**OFFICE OF THE PRINCIPLE CHIEF CONSERVATOR OF FOREST, HOFF,
RAJASTHAN, JAIPUR**

In referenced to para 34/N, CCF resubmitted the proposal after amendment corrections. User Agency submits digital maps of the proposal FP/RJ/Road/6994/2014 as per required by MOEF & CC for their letter no.8B/Raj/06/6/2015/FC/1469 dated 11.03.2016. After examination of digital maps some query in the submitted digital maps.

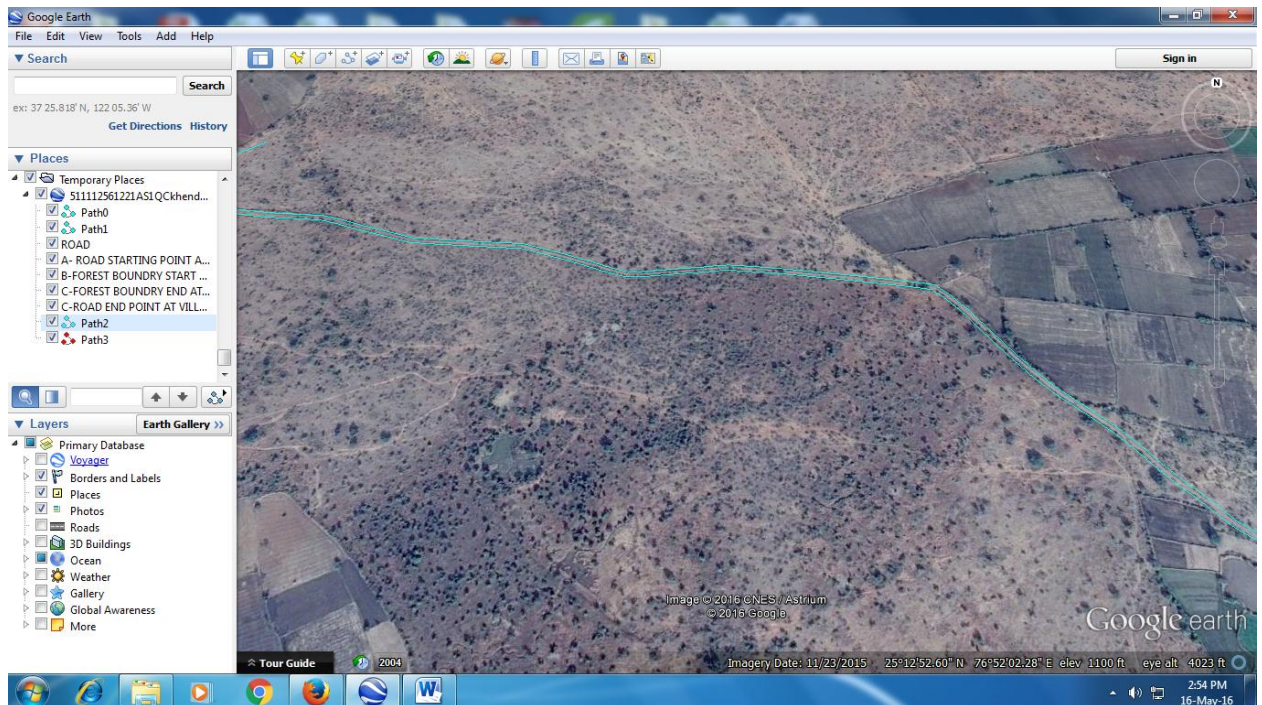
1. Digital Maps are in polyline shape while MOEF &CC required in polygon shape for DSS analysis.
 2. Sheet No 1 expressed that provided digital maps are prepared in path. Total path are 4.
 3. Sheet no 2 expressed that provided digital maps are in line shape.
 4. Sheet No 3 expressed that provided digital maps have a length of 4125 meter in forest while the length of road in forest is only 2050 meter.
- Hence, Digital maps are not satisfactory, the proposal is to be forwarded to CCF for modify/ revised digital maps.
